Limerick Generating Station, Units 1 & 2
Facility Operating License Nos. NPF-39 and NPF-85
NRC Docket Nos. 50-352 and 50-353

Subject: Supplement to the Request for License Amendment Related to
Application of Alternative Source Term, dated February 27, 2004

Response to Request for Additional Information

M-0102, General Arrangement Plan at Elev. 217'- 0"

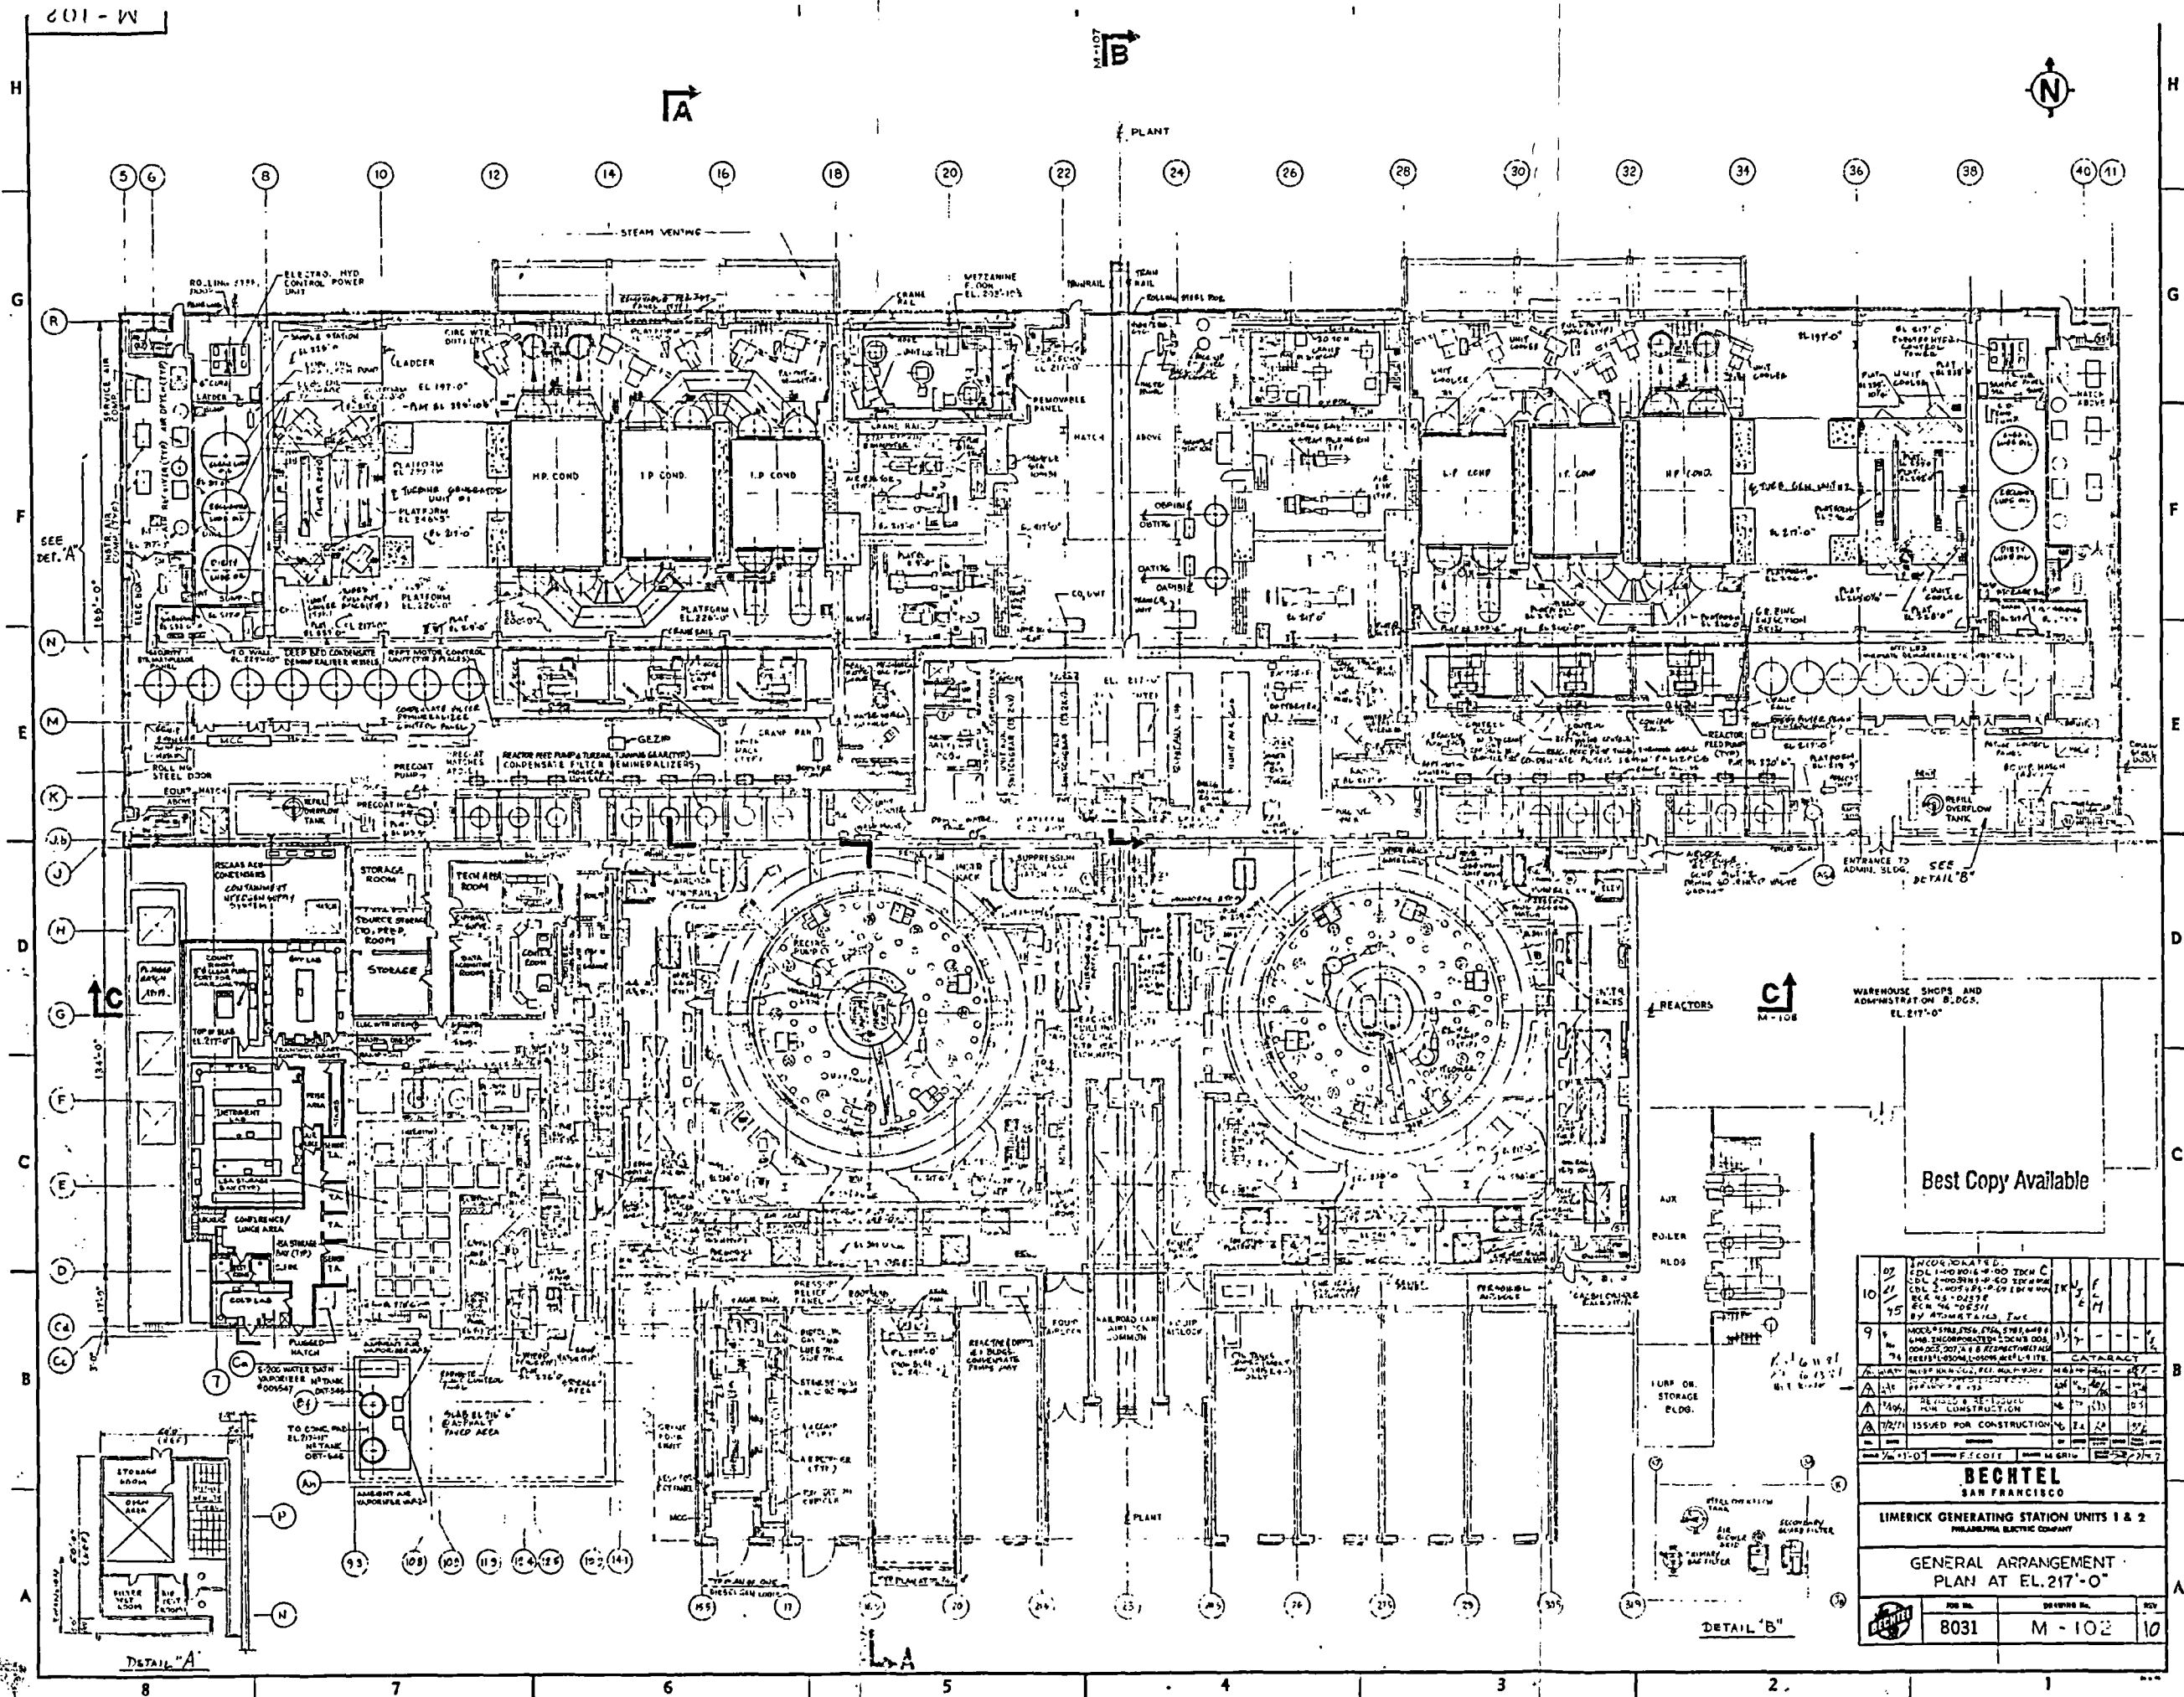
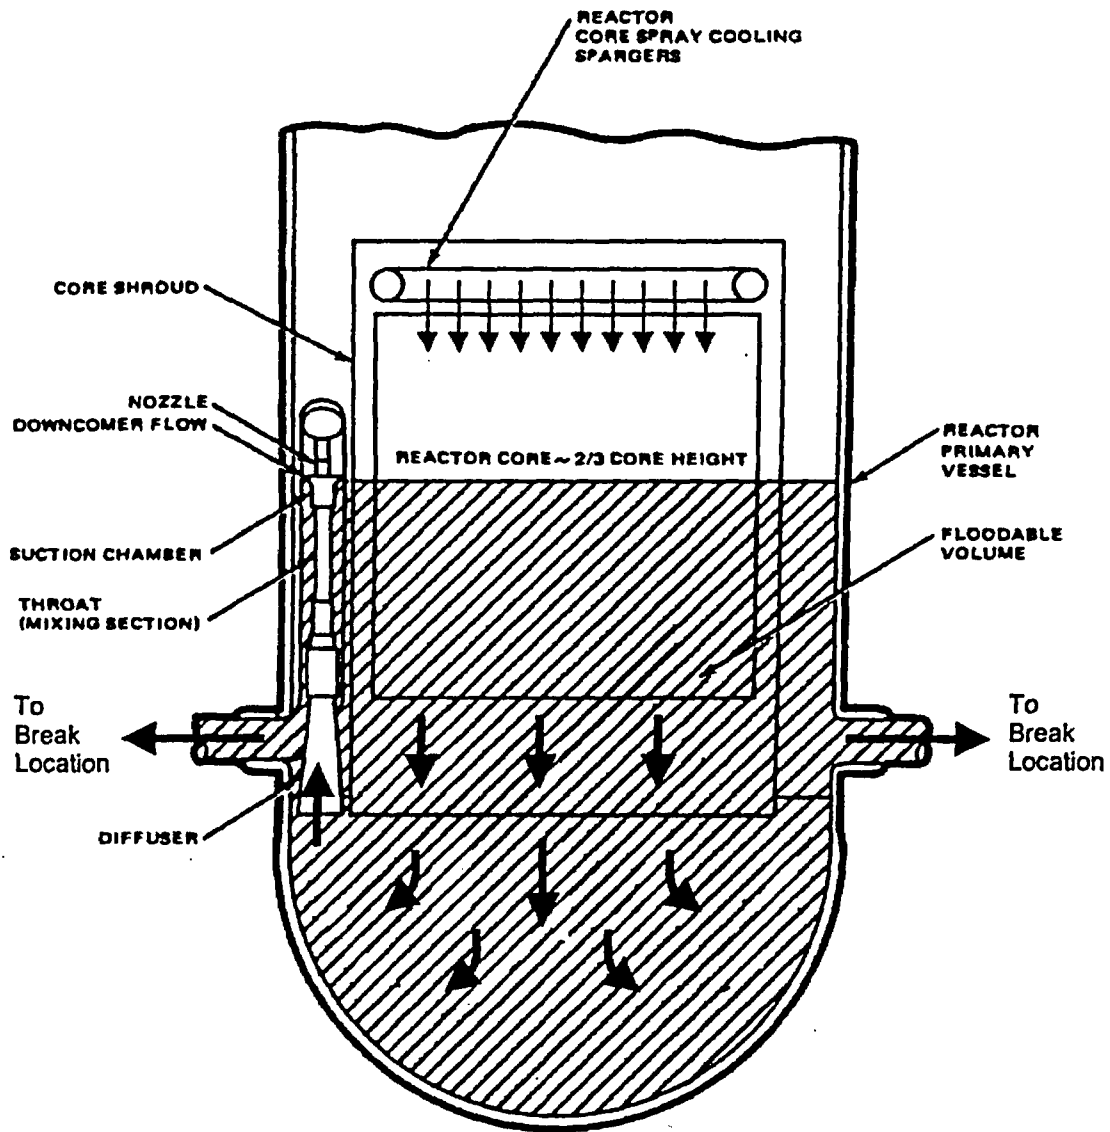
23. The proposed change to TS 3.6.5.1.2, "Refueling Area Secondary Containment Integrity," will no longer require that the secondary containment be operable during the movement of fuel assemblies that have a decay period of at least 24 hours. The fuel-handling accident (FHA) analysis assumes the release to the control room intake and the environment is through the turbine building/reactor building (TB/RB) ventilation south stack. Please justify that an FHA release through the TB/RB ventilation south stack is an appropriately conservative assumption given that the secondary containment may be inoperable. Include general arrangement drawings in your response showing the potential release points.

Site walkdowns and specific reviews of the LGS General Arrangement Drawings such as M-102, the Plan at El. 217' - 0" (one foot above Grade) and M-107, the Section showing the North and South Stack, confirmed that there are no potential release pathways that could be worse with respect to the Control Room intake than the analyzed stacks (these drawings are included in Attachment 4).
